SES SOLAR ONE

In Response to Defenders of Wildlife
Data Requests, Set 1: Data Requests 1-11

In Response to Basin and Range Watch
Data Requests, Set 1: Data Requests 1-3

Application for Certification (08-AFC-13)

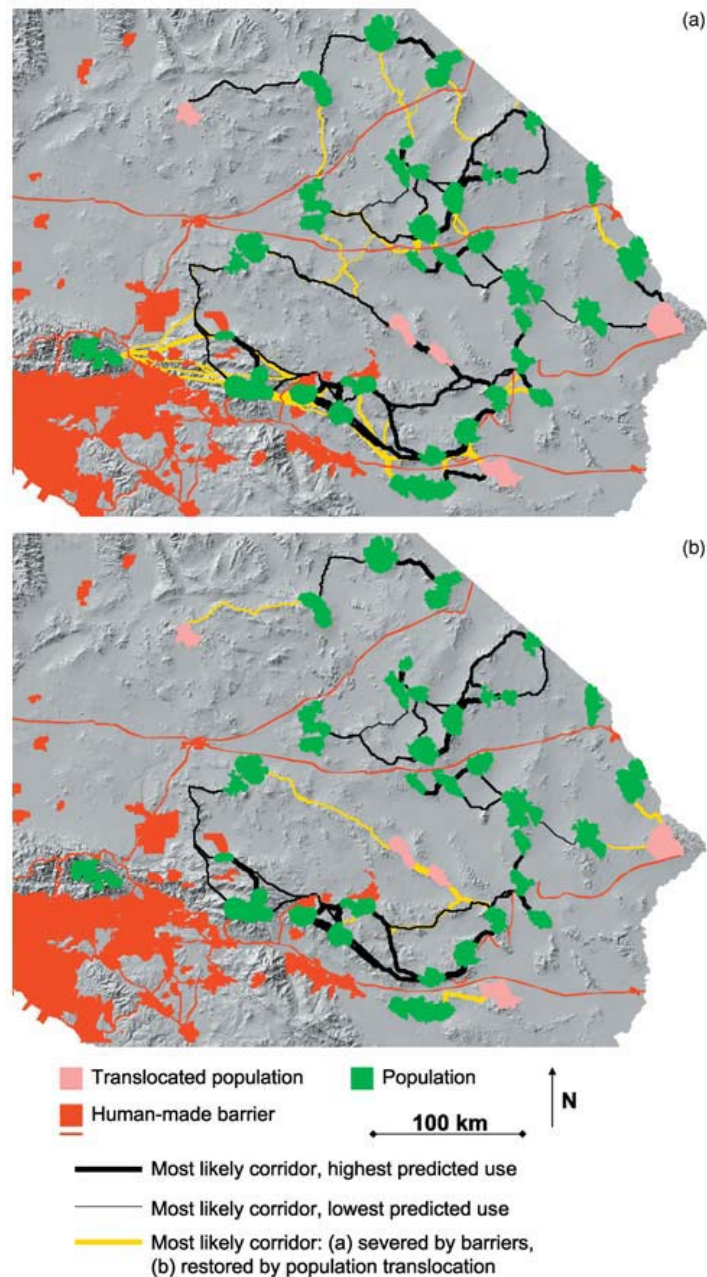
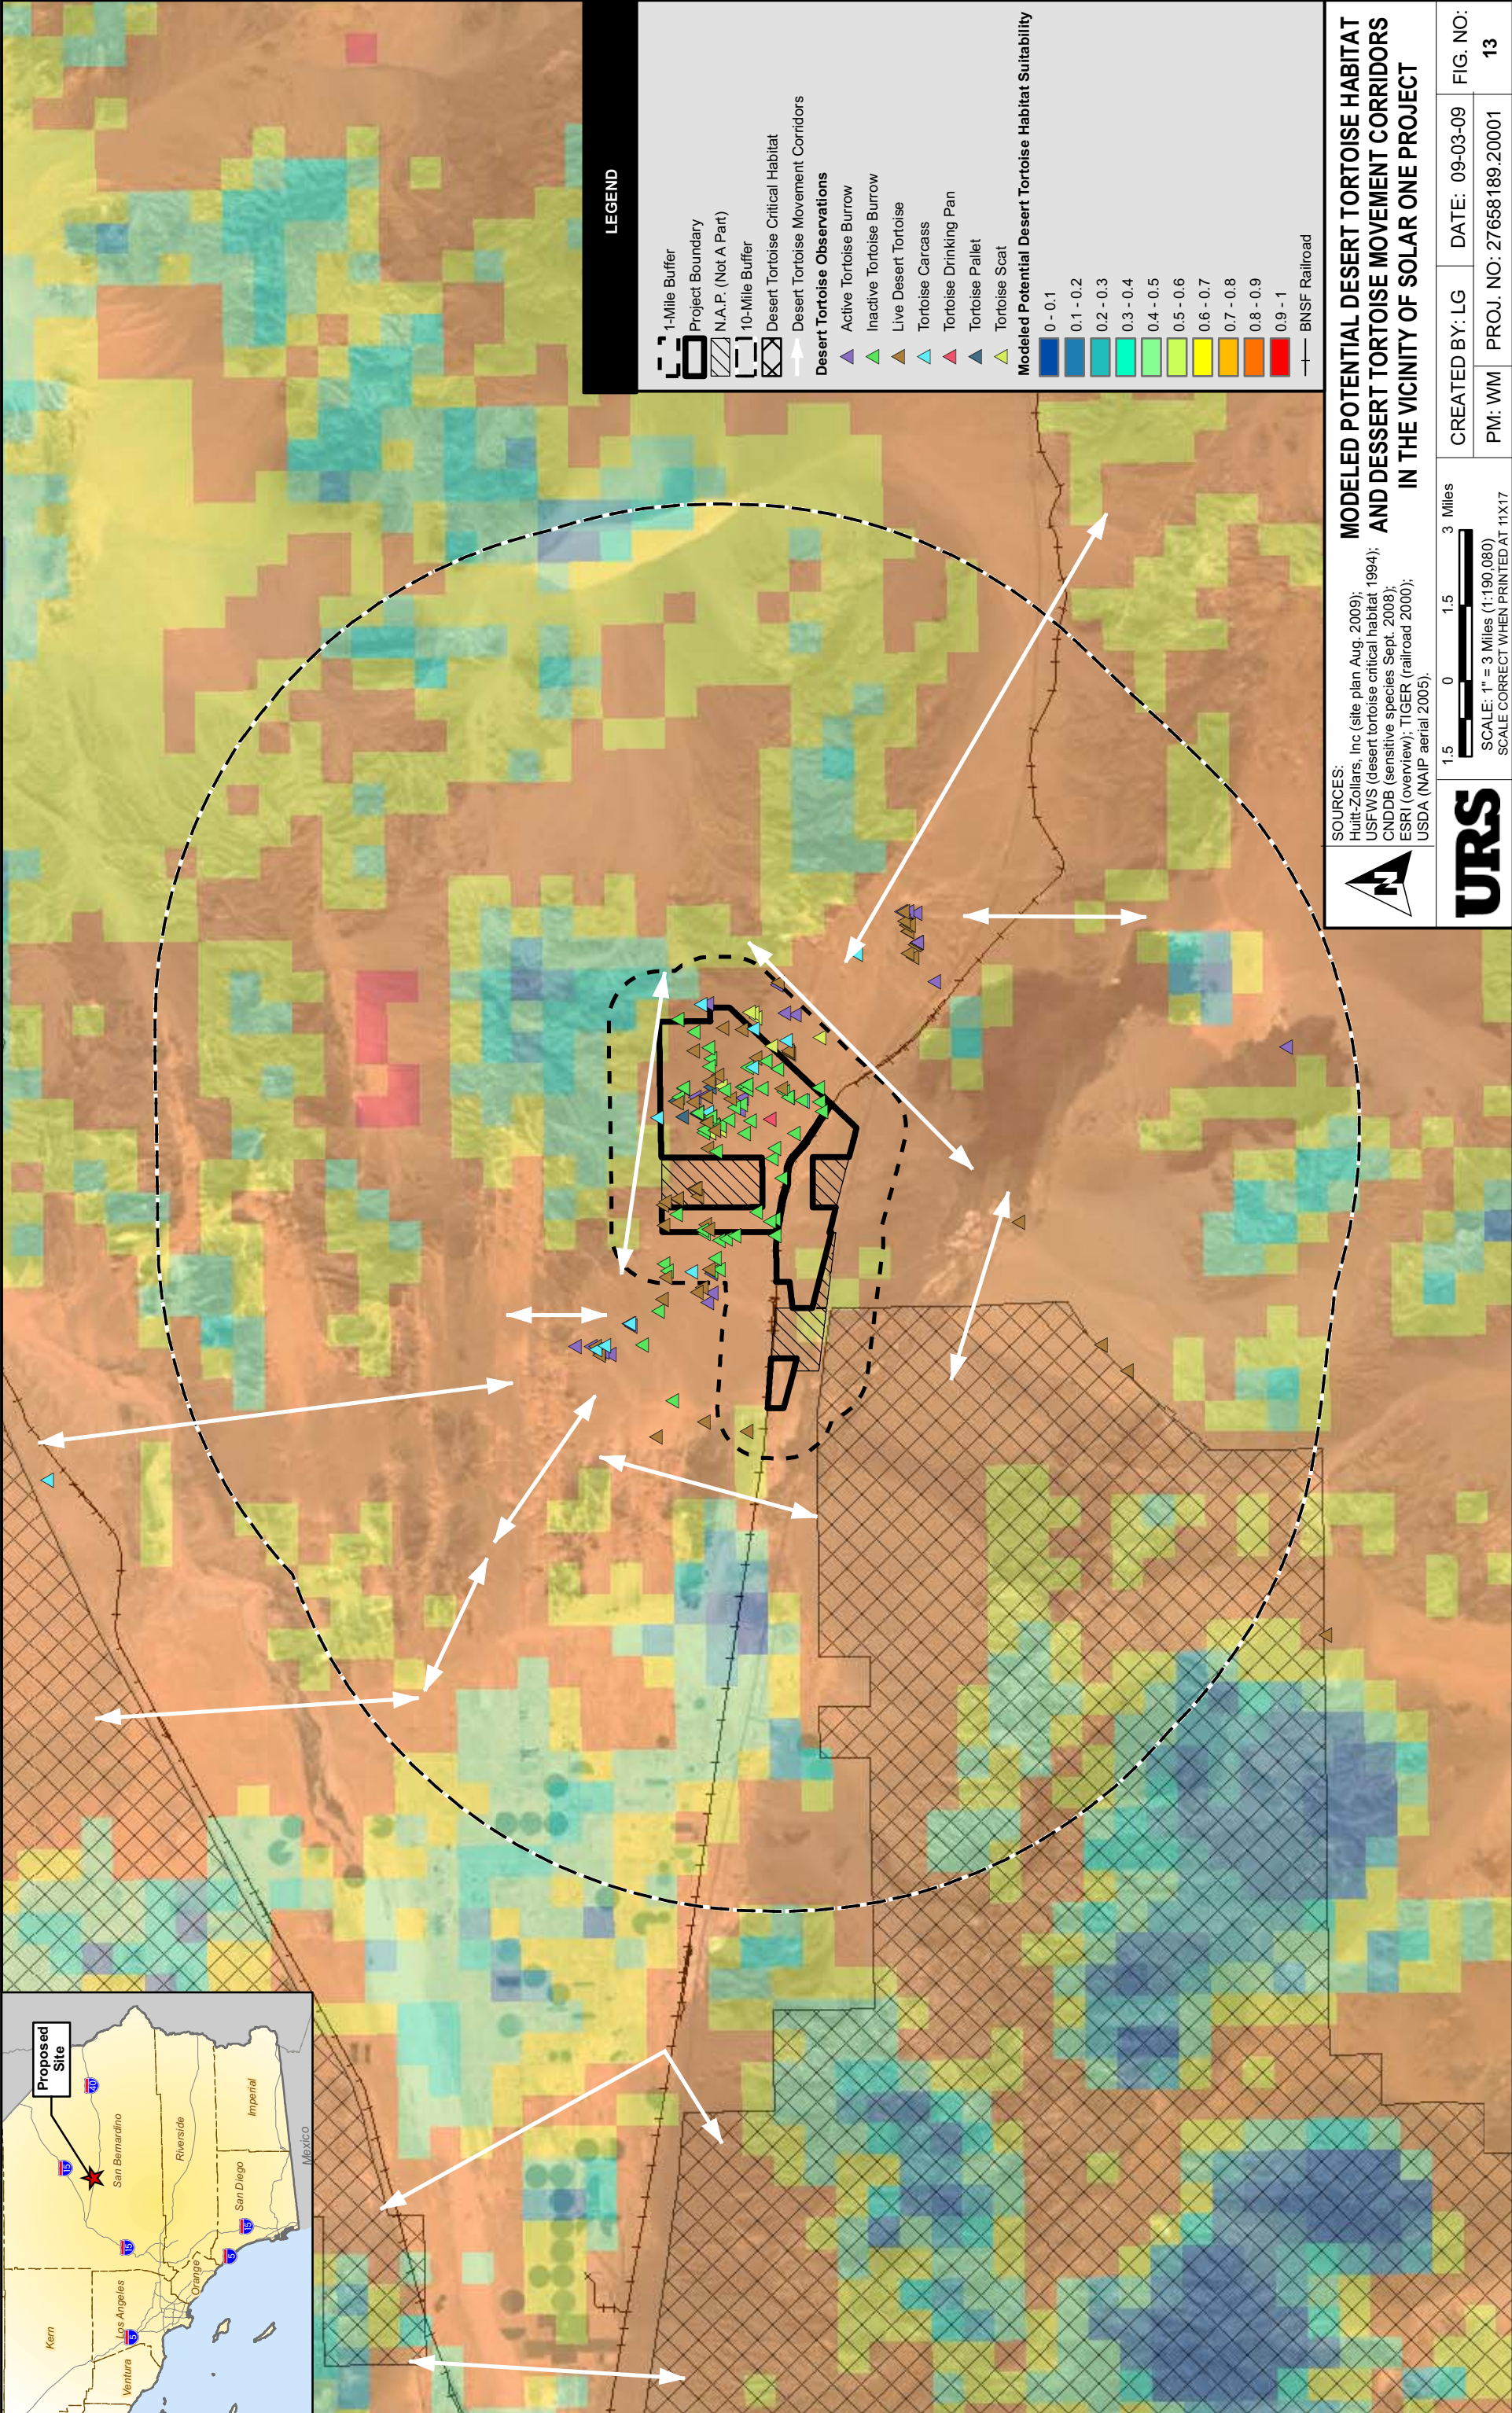
Data Request 2: Please identify the methodology for assessing cumulative effects on desert tortoise and bighorn sheep migration corridors.

Response: Epps et al. 2007 indicate that BHS movement occurs east of the Cady Mountains and north of Interstate 40 (please see the figure provided within this response). Projects proposed in this movement area could potentially impact BHS movement. The winter range of the Cady Mountains herd includes the Pisgah ACEC. Any potential BHS movements south of Interstate 40 would be associated with this BHS use area. Establishment of new herds through translocation between existing herds would enhance metapopulation function through inter-herd exchange of individuals. The Solar One Project is located west of potential BHS movement areas and would not impact BHS movement routes.
